March 18, 2020

**Re: Sunset Land Associates LLC and SH Owner LLC
Response to Staff First Submittal Review Comments - Critical Issue
Planning Board Application (PB20-0344, the “Application”)**

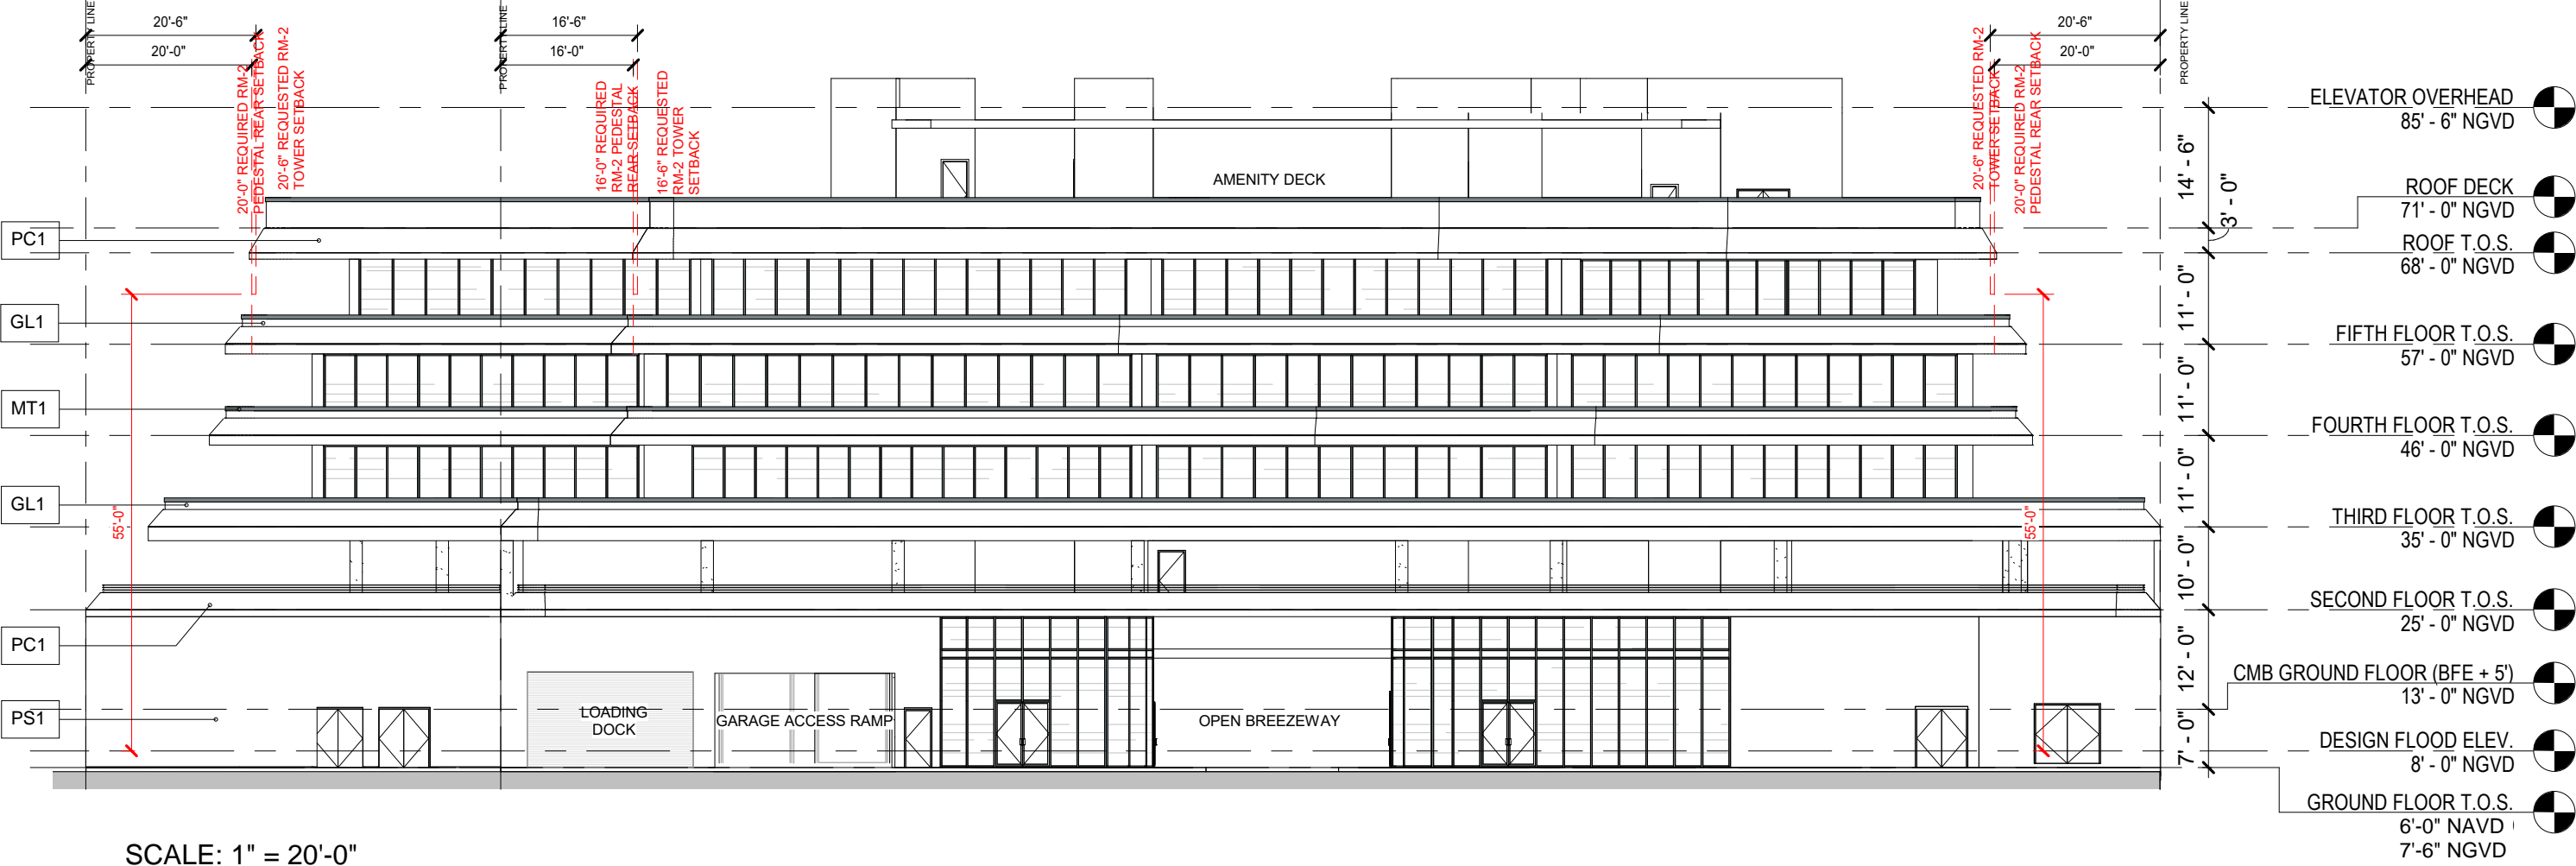
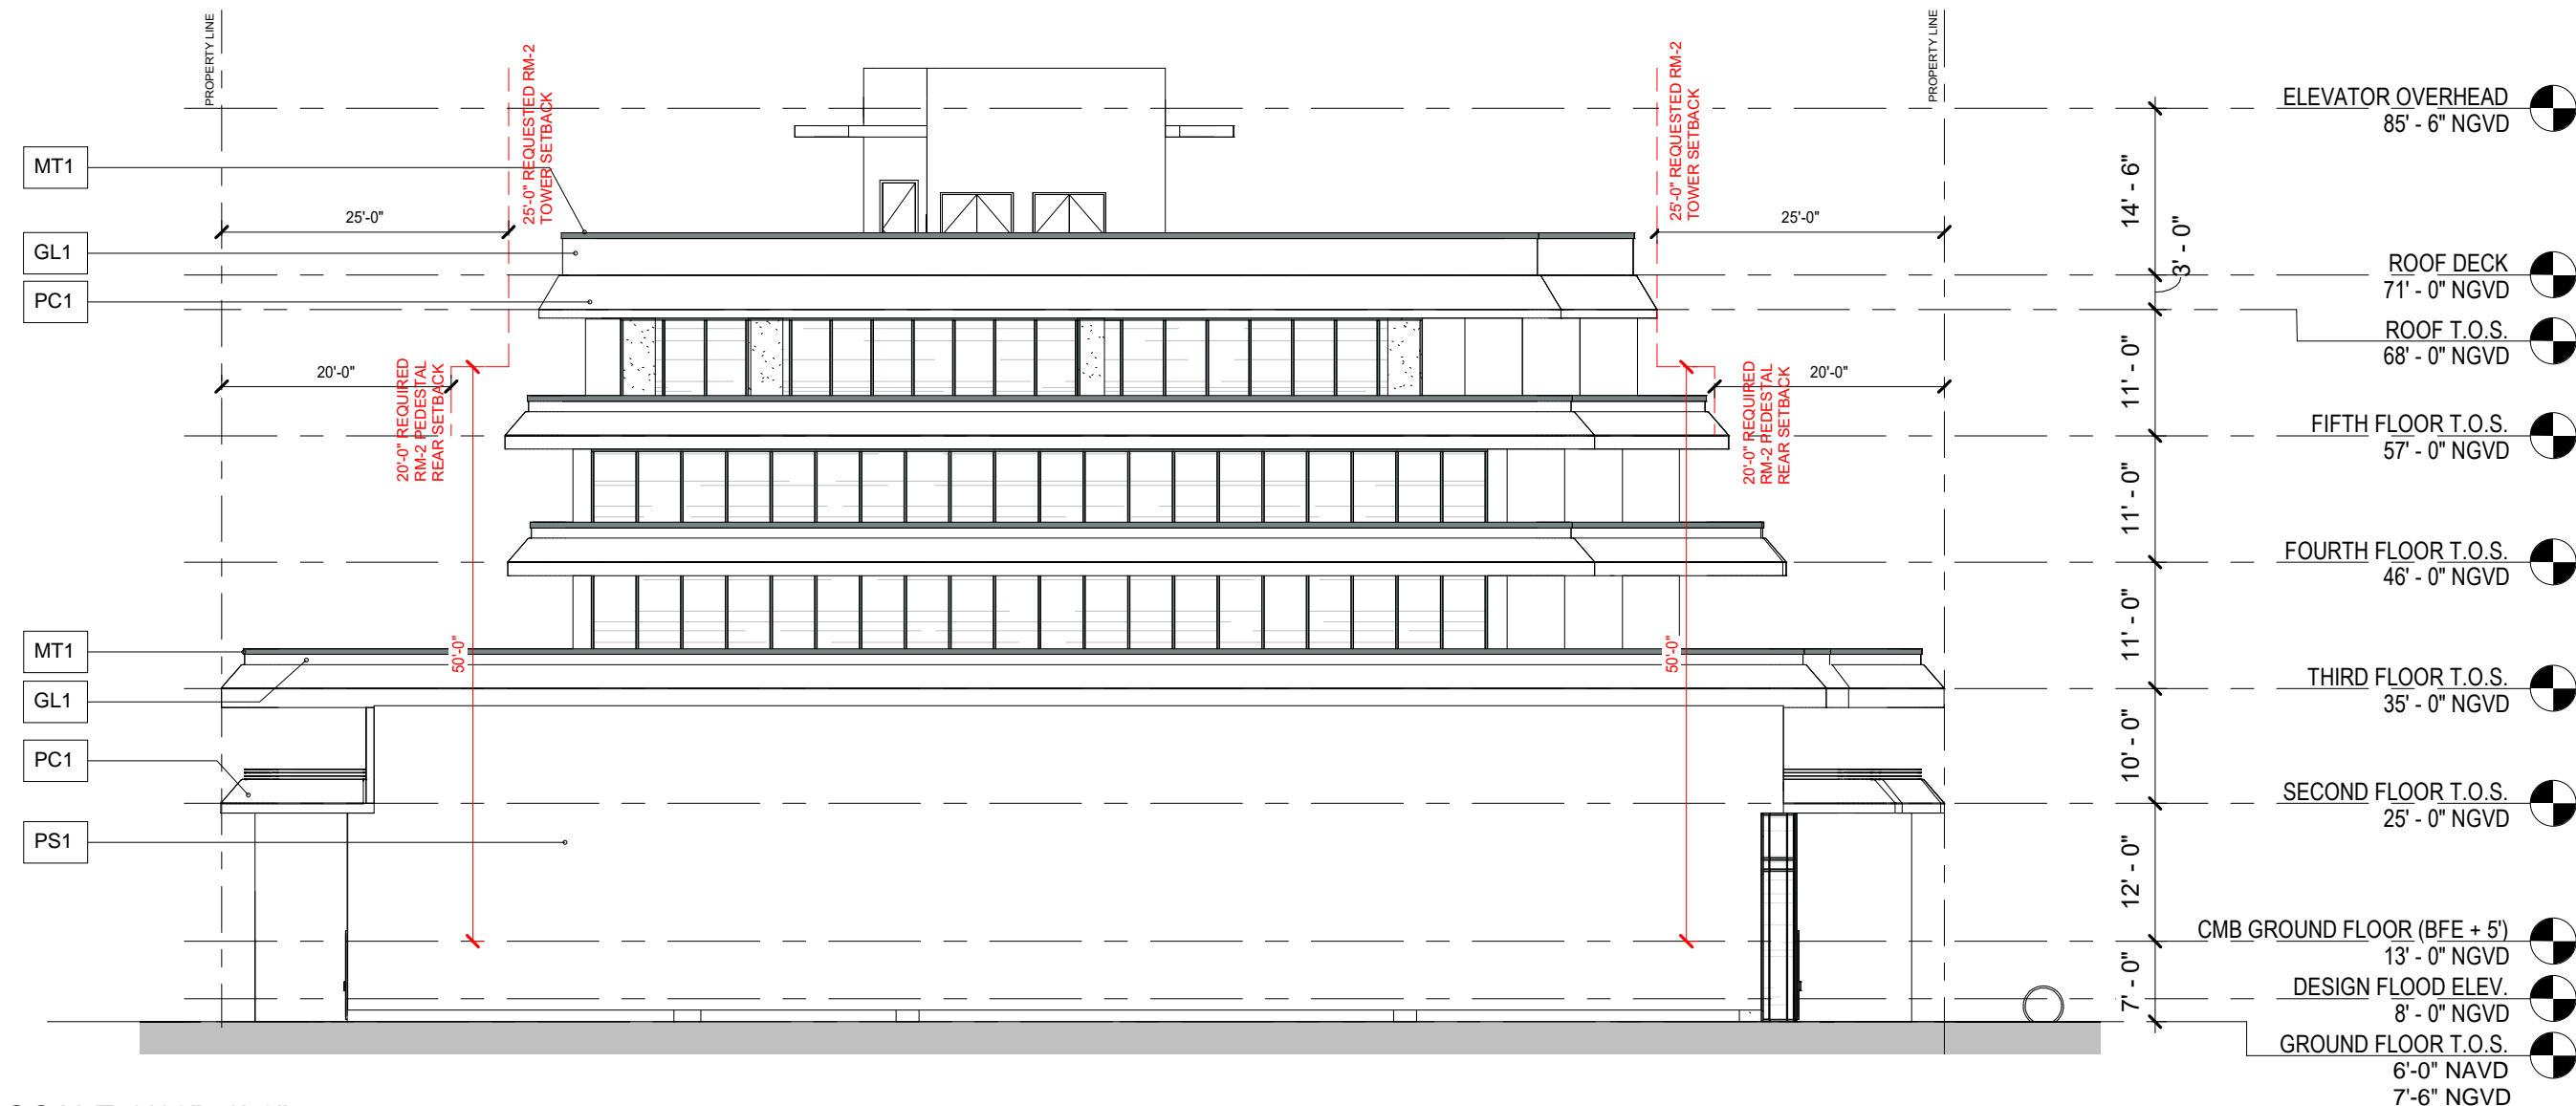
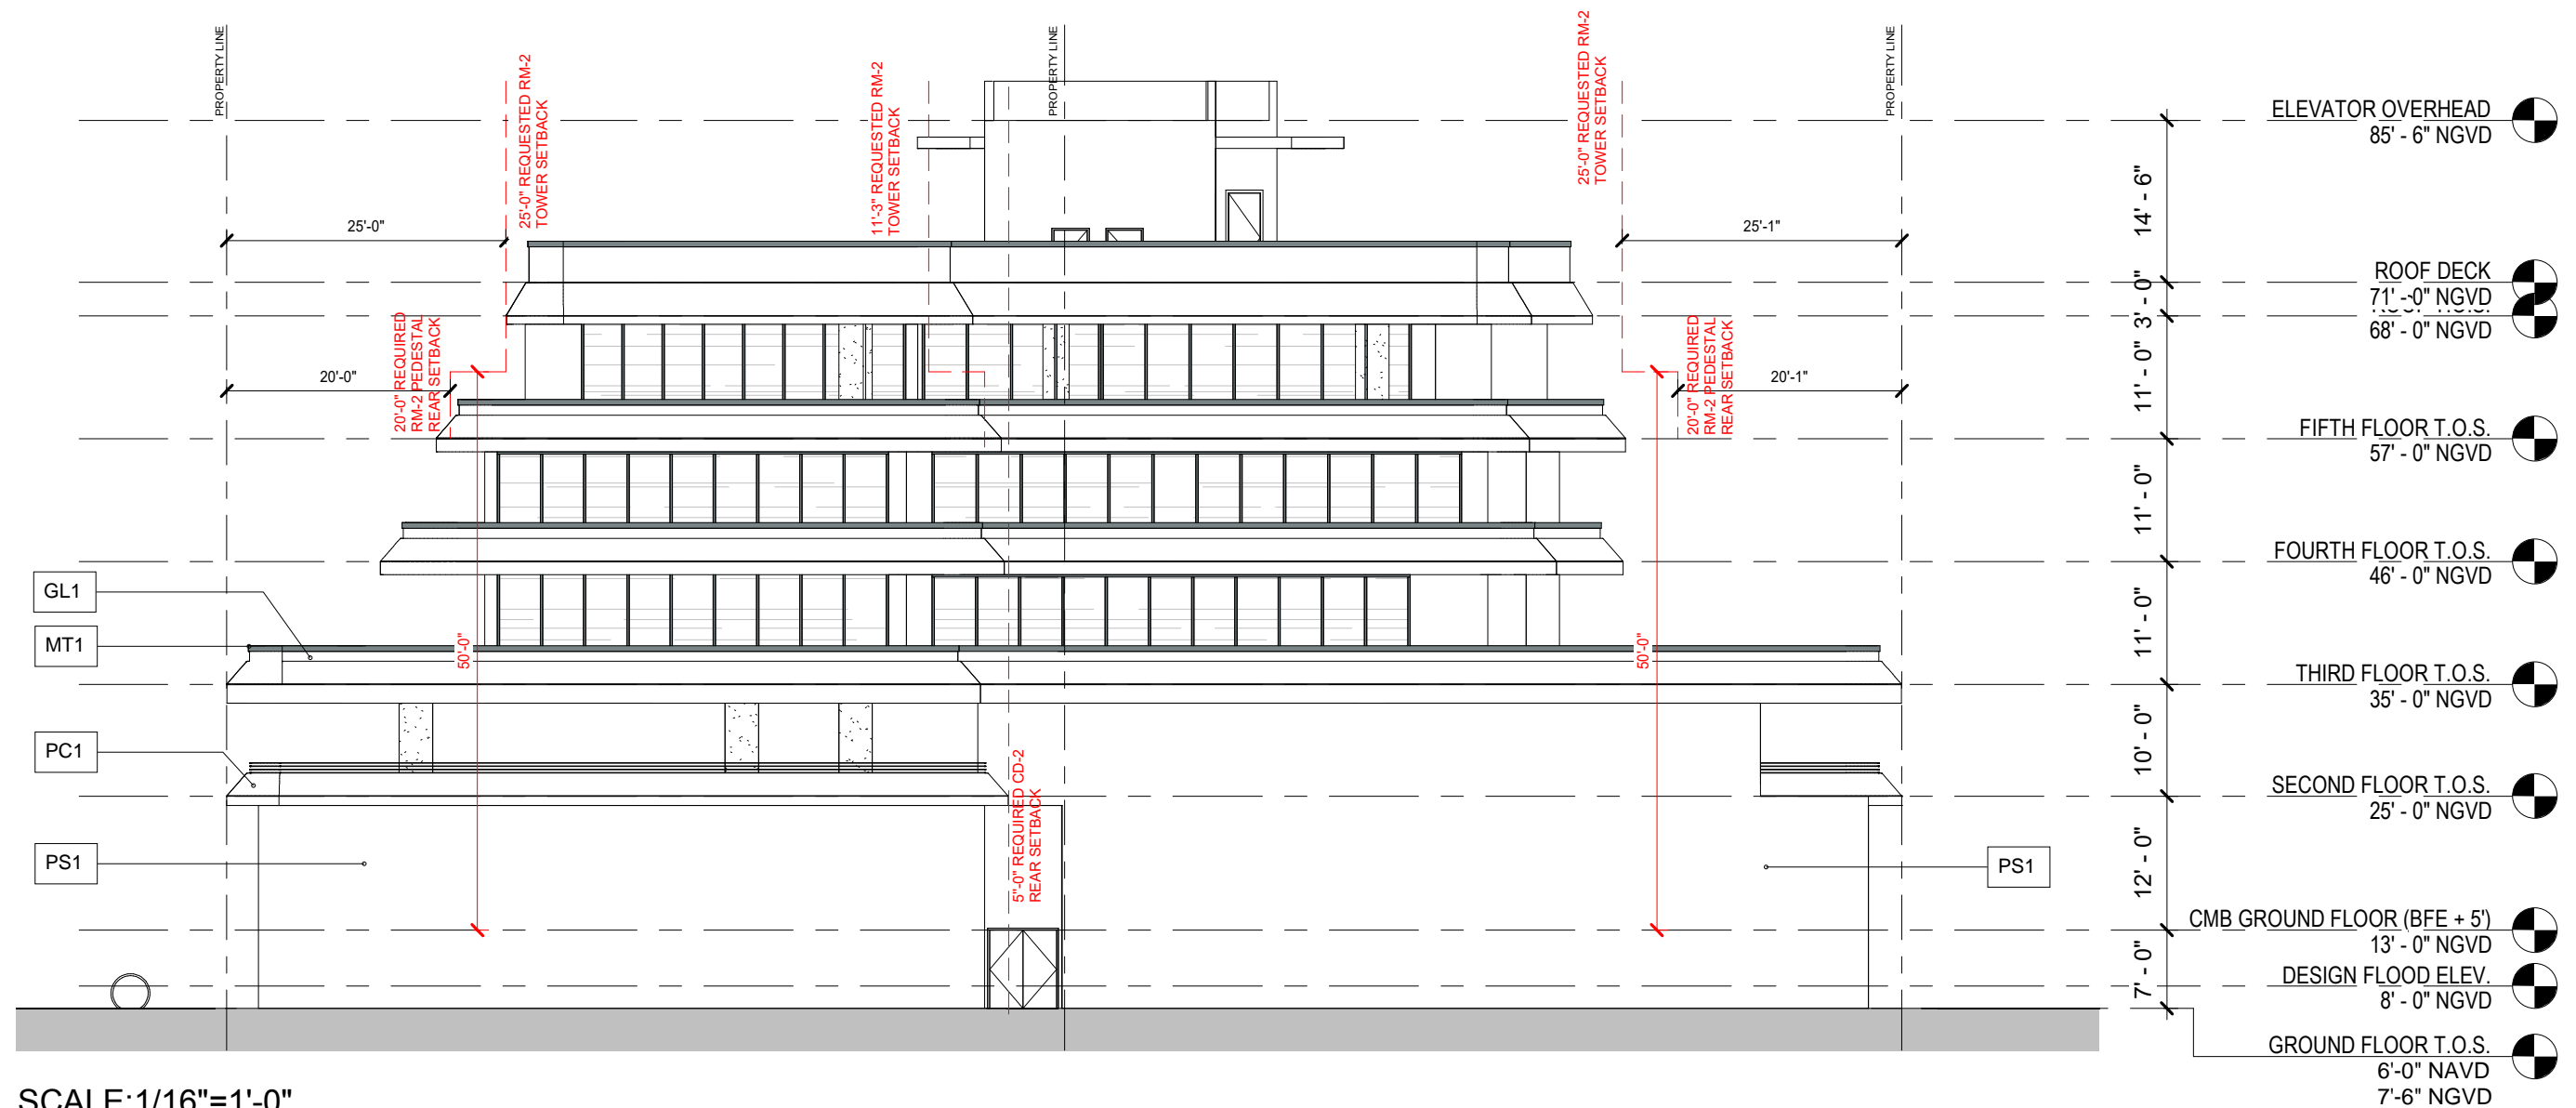
Critical Issue: Staff identified a reduction on the ceiling to floor height on the ground floor and the location of the second level to be lower. This does not comply with CMB code and sea level rise and resiliency review criteria. The first floor shall provide at least 12 feet in height, as measured from the base flood elevation plus maximum freeboard, to the top of the second floor slab in order to get the DRB waiver incentive to measure height from BFE+5 to get the additional 5’ in height as previously approved and shown on page A- 3.8. *Please submit a revised section and elevations for the proposed project By Wednesday March 18, by noon to show compliance. Please make sure all dimensions are legible, as the text is too small. Staff will review this and determine if the applicant can move forward to final submittal or continue to first submittal for PB June Review Cycle.*

Response: Applicant has revised the section and elevations for the project to comply with the City’s Code and sea level rise and resiliency review criteria, as previously approved. Please refer to revised sheets A-3.5 through A-4.0 showing compliance with ceiling to floor height on the ground floor, measured from BFE+5. This submittal has been completed in a timely manner as instructed above.
